ADDENDUM NO. 6

HVAC & CONTROLS REPLACEMENT/ADDITION AT NINE (9) SITES: BARRANCA, BEN LOMOND, CYPRESS, GROVECENTER, MANZANITA, MERWIN, MESA, ROWLAND, AND WORKMAN ELEMENTARY SCHOOLS RFQ/RFP #22-23-105

January 19, 2023

10 M7.2 DUCT SUPPORT IN CEILING SPACE NO SCALE

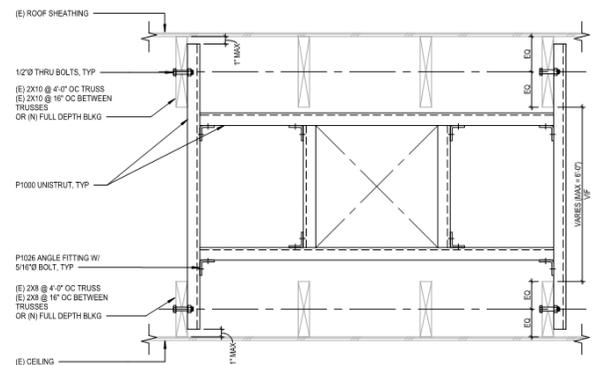
Detail 10/M7.2 is shown in the details but does not match site conditions, can you explain where this would apply at any site?

DLR Structural Response:

Detail 10/M7.1 is to be used to support the ducts running in between the space between the ceiling and roof at Ben Lomond, Cypress, Grovecenter, Rowland, and Workman. The photo below is the classroom ceiling space at Rowland ES.

DLR Mechanical Response:

It applies to the duct in the ceiling space of the classrooms. Refer to section details 1/M1.1C & 2/M1.1C.

5 BOWDEN TYPE CABLE CONTROL (YOUNG'S REGULATOR)
M7.2 NO SCALE

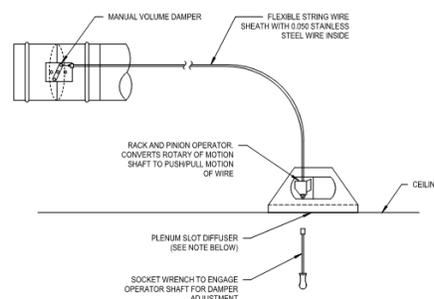
- Confirm if all hard-lid ceilings will require remote dampers?
- If required, will we have to provide an access door at each damper?
- Will this affect all sites?
- Will Pottorff type be acceptable?

The RFI didn't call out the school name. The response is based on Ben Lomond as called in RFI #2&4, and the other schools with same condition.

1. Confirmed. All hard-lid ceilings require remote regulators for the dampers.
2. No additional access is required. There is an existing access door at the classrooms for above ceiling space.
3. This applies to all the sites under the same condition.
4. Please use Young's Regulator as designed.

DATE:	01/17/23		
FROM:	Scorpio Enterprises dba AireMasters A/C	EMAIL:	tdean@airemasters-ac.com
DOCUMENT/DIVISION NUMBER:	Mechanical Plumbing	DRAWING NUMBER:	MP1.1/#1 Ben Lomond

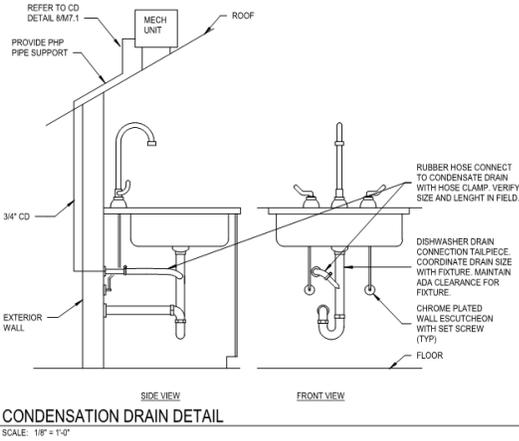
HVAC Condensate at sites applicable:

- Does it need to be insulated?
- Does it need to have a sheet metal cover?
- Are we to core drill the concrete walls for the condensate?

DLR Mechanical Response:

1. Refer to specs 232113. No insulation is required except ADA wrap under sinks where required.
2. No sheet metal cover is required for Plumbing.
3. No concrete walls in the classroom buildings.

DATE:	01/17/23		
FROM:	Scorpio Enterprises dba AireMasters A/C	EMAIL:	tdean@airemasters-ac.com
DOCUMENT/DIVISION NUMBER:	Arch/Structural	DRAWING NUMBER:	1/M1.1C

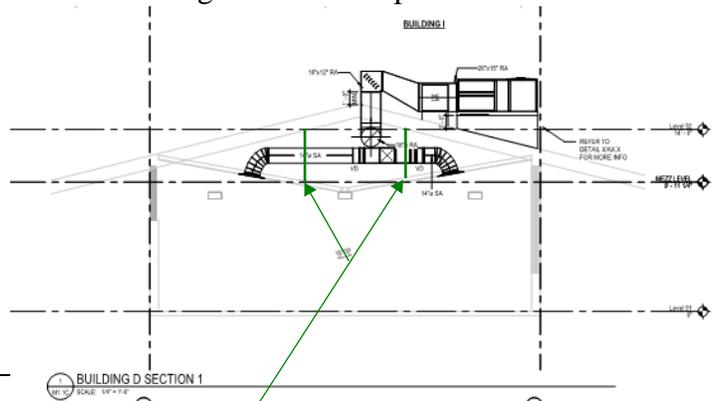
On the jobwalk we were not able to see the condition/design of the attic space and the details lack information, are there catwalks up there?

Please provide above ceiling attic space As-Builts for reference at applicable sites.

DLR Structural Response:
Refer to RFI-04. This is where the detail is applicable for the duct support.
